South End Landmark Historic District Commission

Project Review Hearing

34 East Springfield Street

Revisions from SELDC approved plans

**Updated
sightline**

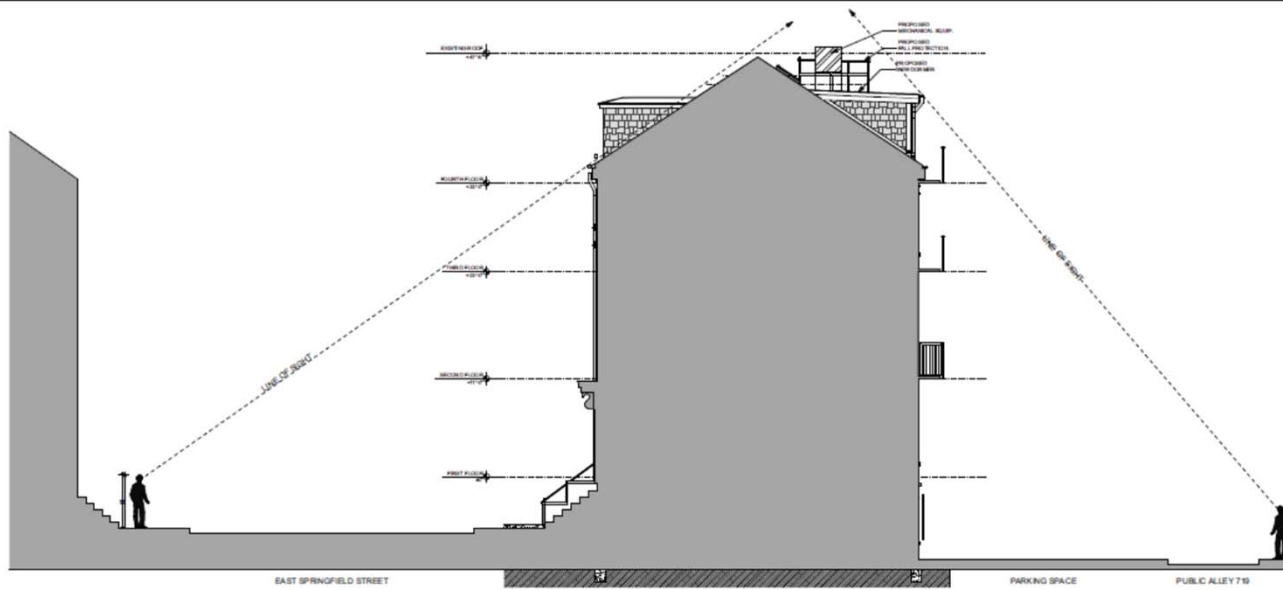
Only three units will now be on the roof. We would request a mock-up be done after the new dormer roofline has been constructed. If necessary, the location of equipment and fall protection can be revised at that time.

Updated roof plan

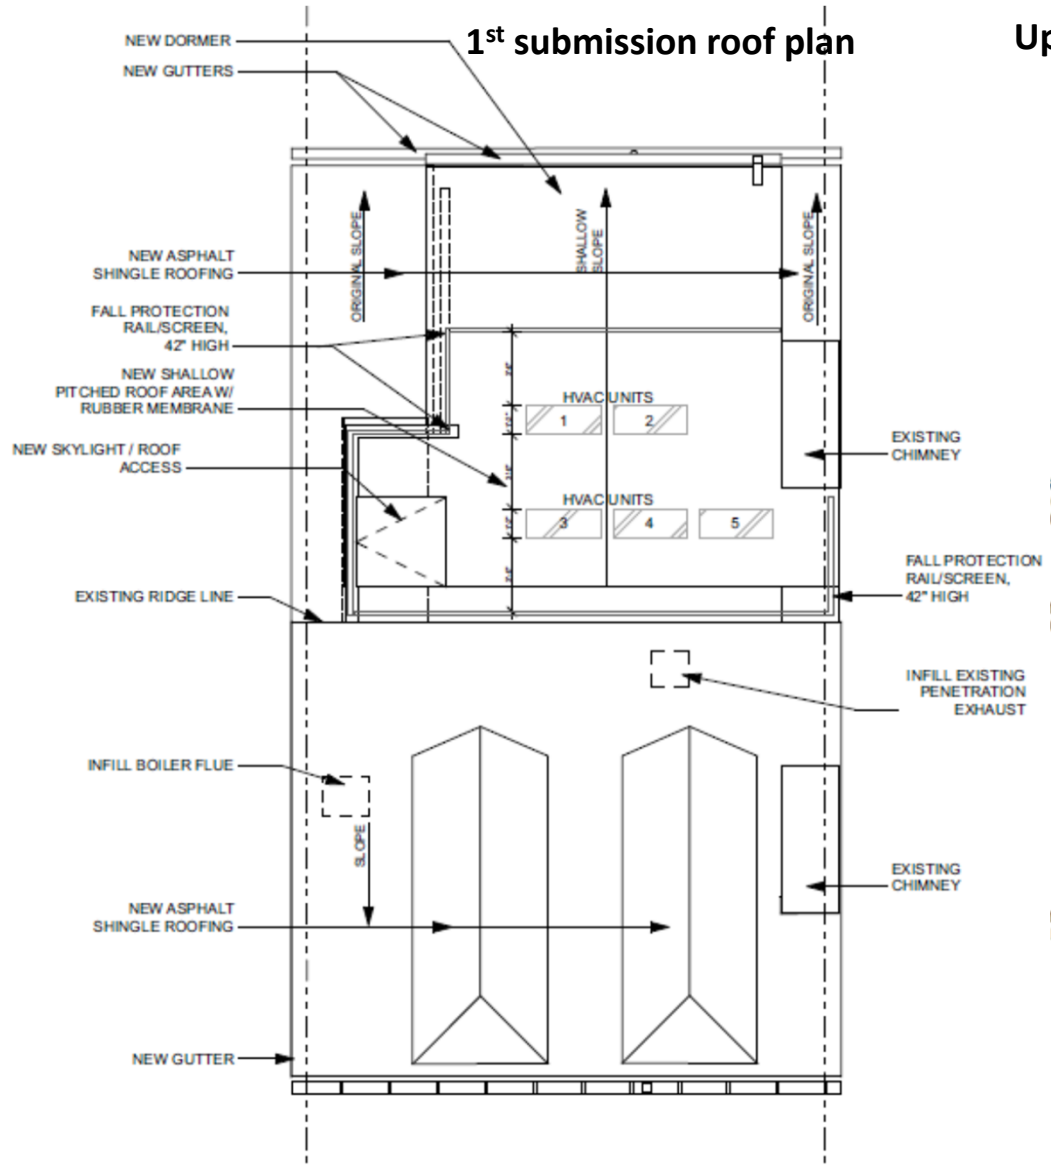
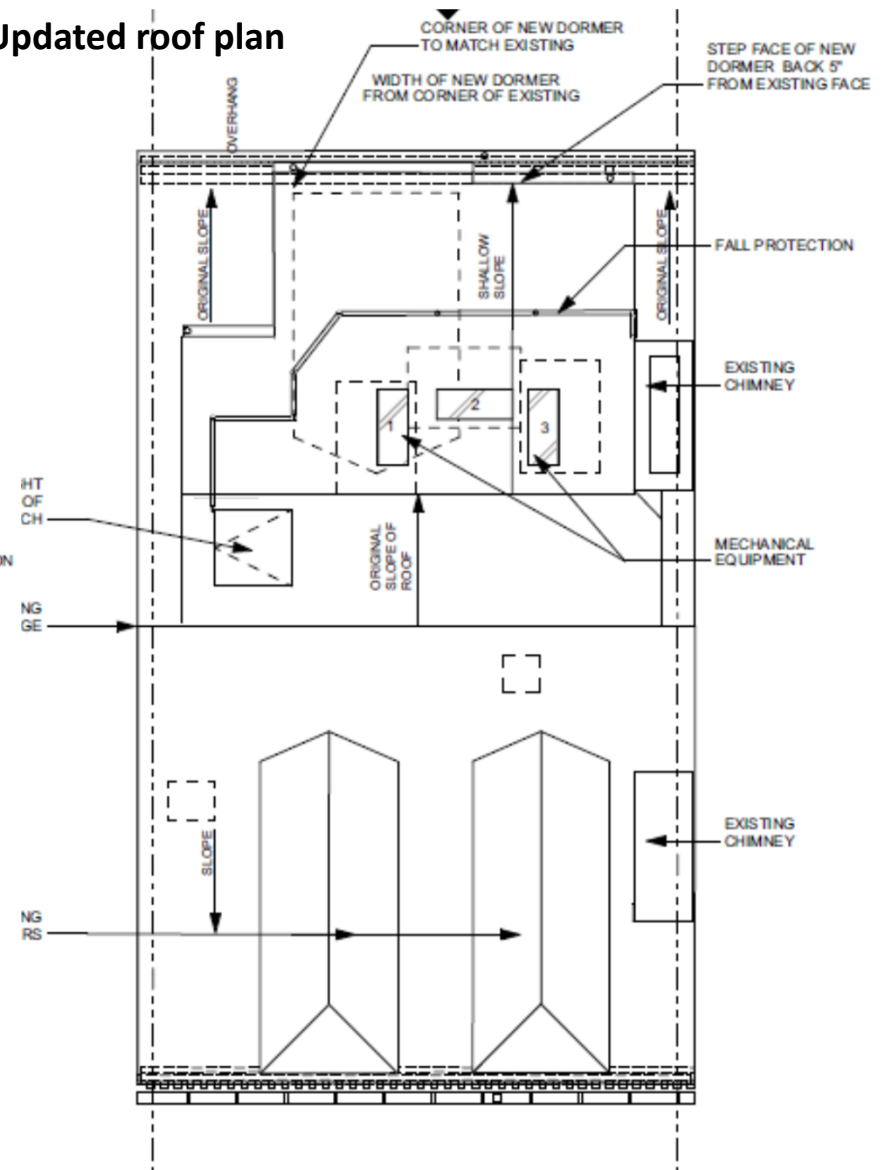
The dormer roof now intersects lower on the rear slope of the roof, the design has also been revised per SELDC requests to make existing dormer location more prominent with a 5-inch setback denoting the existing dormer's location. The equipment screen has been eliminated in place of a railing system.

Updated window jamb

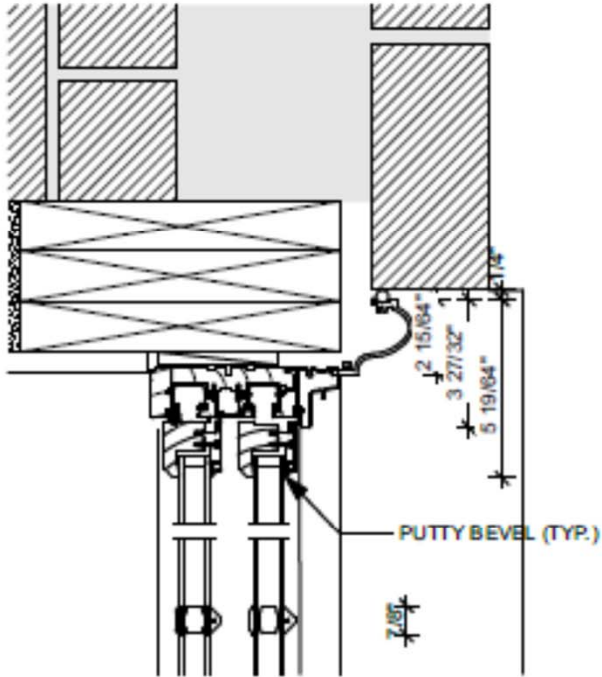
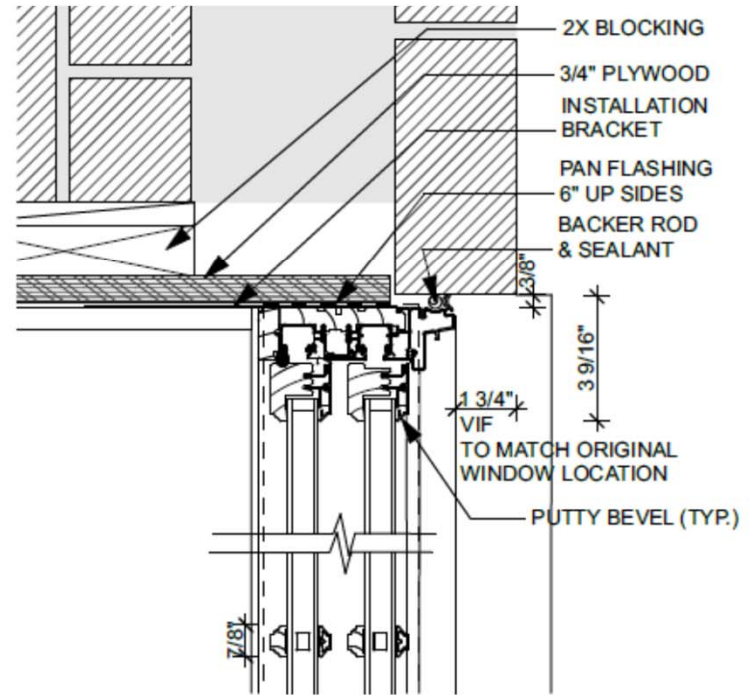
NPS required a change to the proposed brickmold, requiring removal of the ogee curve in order to reduce the thickness of the frame. Other window details remain the same as previously approved.

Expanded site plan for front yard

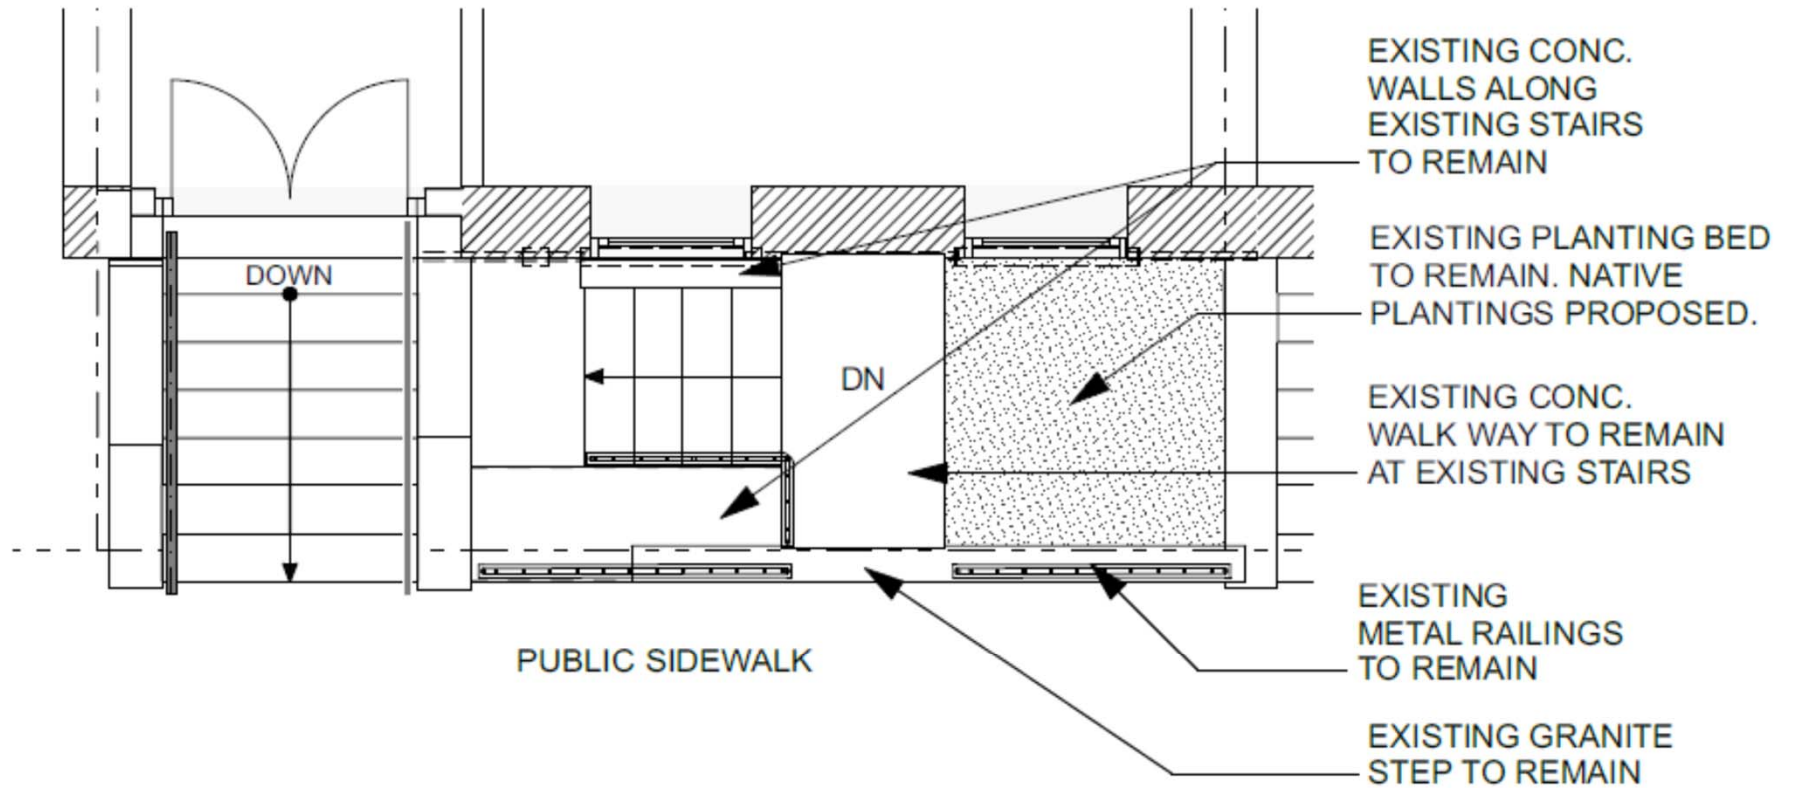
At the request of the SELDC, we are including a drawing of the planting area at East Springfield Street, please note no changes are proposed, aside from planting new flowers.
